**LIFT TYPE:- STANNAH HOMELIFT**

**Re:- Adjustment of Stannah Homelift Concertina Panels.**

DRG TITLE: <b>CONCERTINA PANELS RETROFIT NOTICES</b>	
 <b>HEAD OFFICE</b> Anton Hill Anton Hill Rd Andover Hampshire SP10 2HG England Tel: 01264 339990 Fax: 01264 337942	
PRINT ISSUED:	
DRAWN: Dave J	DATE: 24/8/98
DRAWING NUMBER:	REV.
<b>HD3036</b>

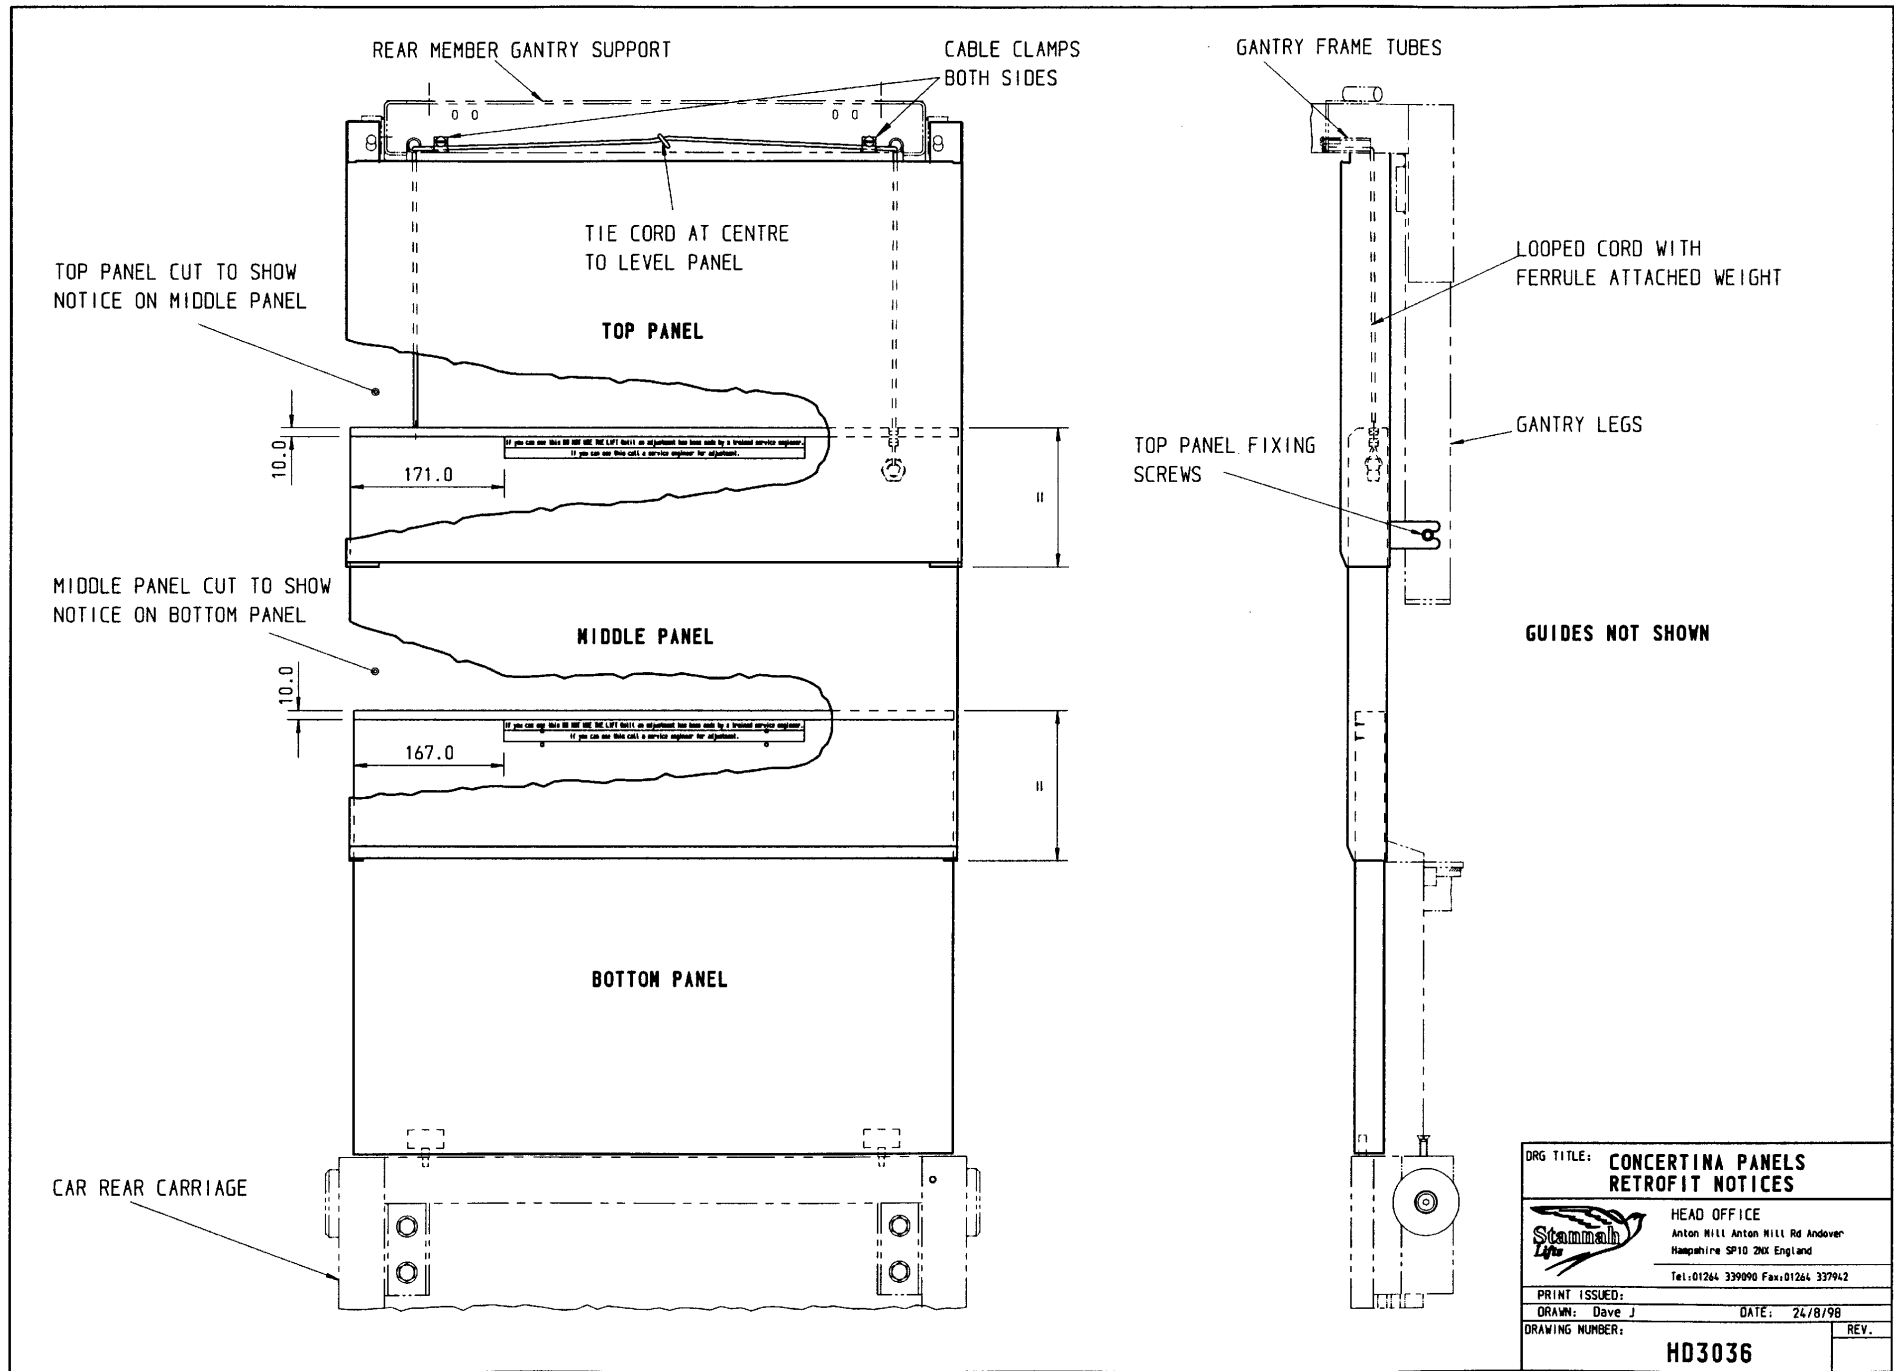
It has come to our notice that some of the Stannah Homelifts in the field have not been maintained with the correct adjustment/overlap of the rear concertina panels.

A safety label has been made available and we would recommend that this be fitted as shown to all units in the field to ensure that the overlap does not exceed the minimum dimension shown.

Should any Homelifts be found with insufficient overlap, the panels should be adjusted so that equal overlap is achieved.

See drawing HD3036 attached for precise positioning of the labels.
